Access Compliance Report Public Rights-of-Way (Pedestrian Signals)

Main Street: LINCOLN_AVE Cross Street: ORANGE_OLIVE_RD Location: SE

ADA ID: SGAT220127100451 Signal Type: One Push Button-Non APS Overall Compliance: No Severity Scores: BTN 1: 35 BTN 2: N/A No BTN: N/A

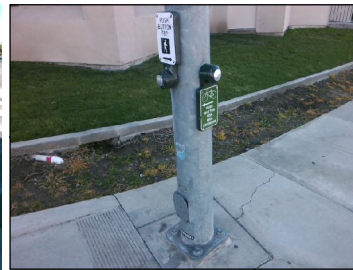
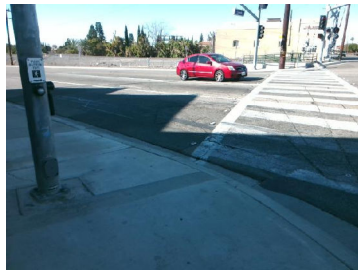
Surveyor Notes: Button 2 for Bike Lane

Possible Solutions: Replace Signal Push Button With APS Button. Remove and Replace Clear Space.

OC Std/PROW: R404.2, R404.3, R403.4, MUTCD 4e.08
